CITY OF ALBUQUERQUE

**Re: Lot 12 Block 6 Volcano Cliffs Unit 5
8009 Victoria Dr. NW
Grading & Drainage Plan
Engineer's Stamp dated: 9-12-17 (E10D037)**

Lots 12, Block 6
Volcano Cliffs Subdivision, Unit 5
GRADING PLAN

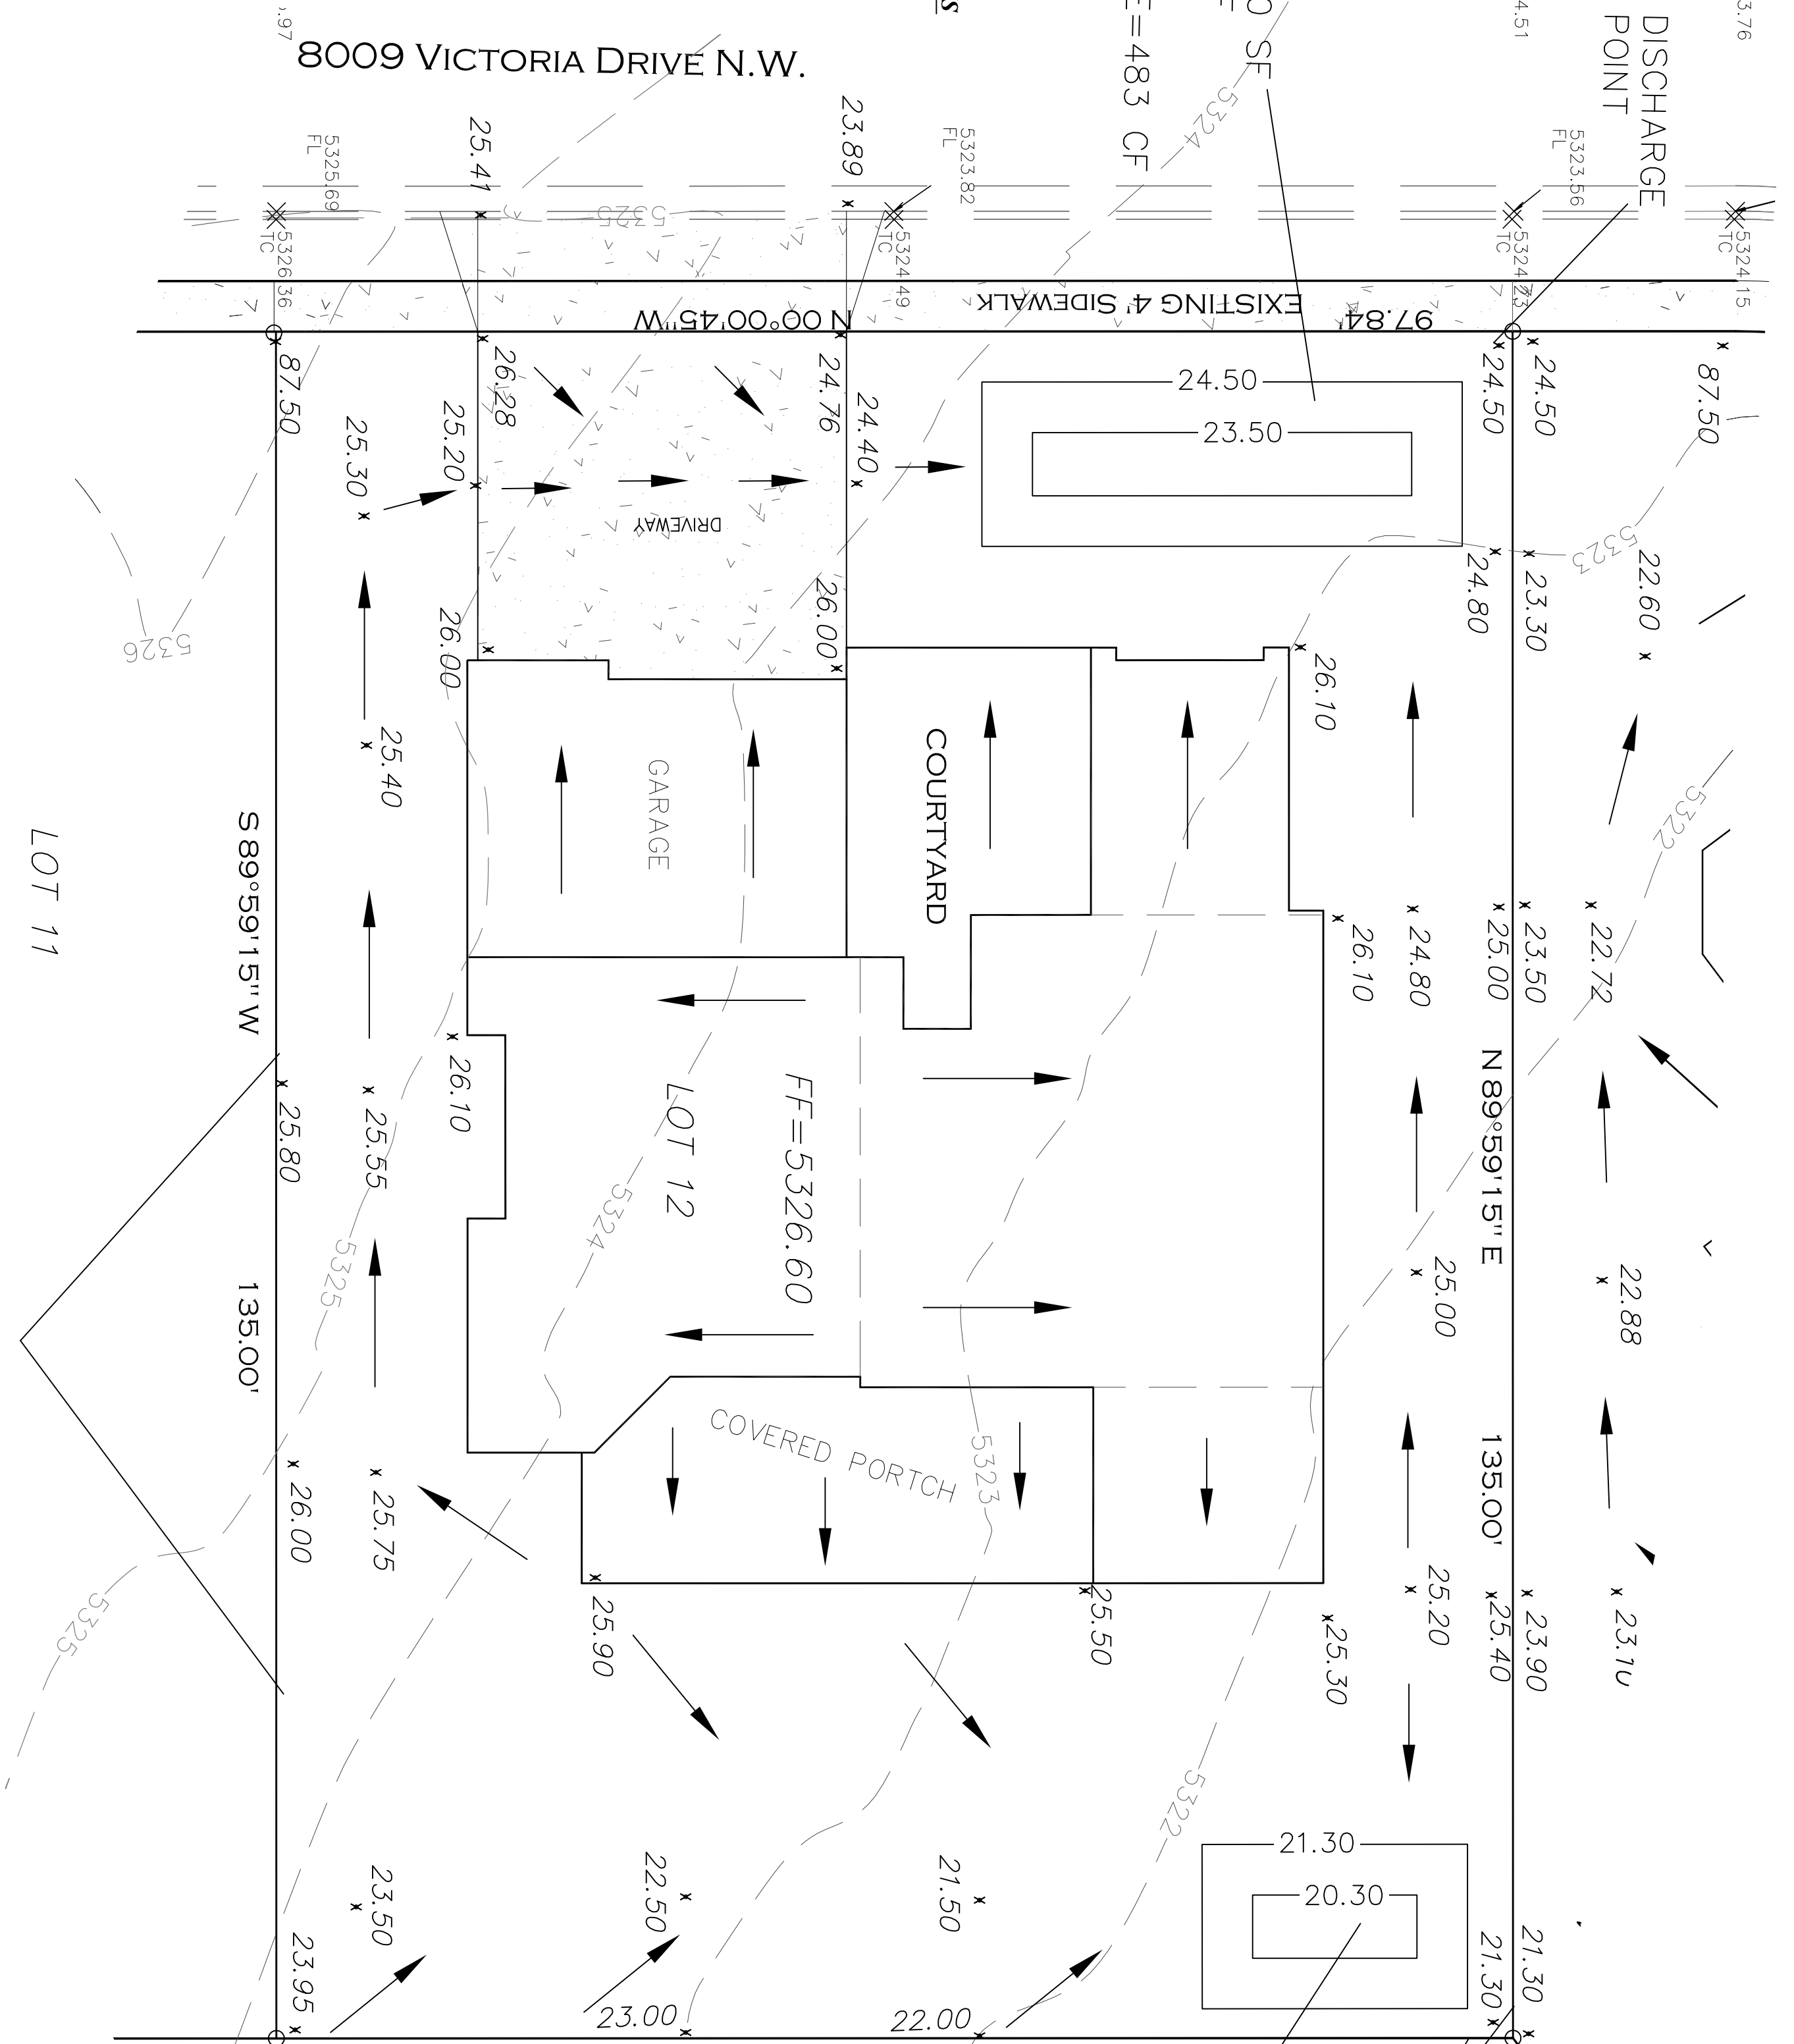
Based upon the information provided in your submittal received 9/14/2017, this plan is approved for Grading Permit.

Reiterate to the Owner/Contractor that a separate permit for a garden/retaining wall must be obtained, with the approved G&D plan dated 9/12/17.

Prior to Building permit approval a Pad Certification will be required, provided by the Engineer with pad cert language or a registered Land Surveyor with as build spot elevations.

Prior to Certificate of Occupancy release, Engineer Certification per the DPM checklist will be required.
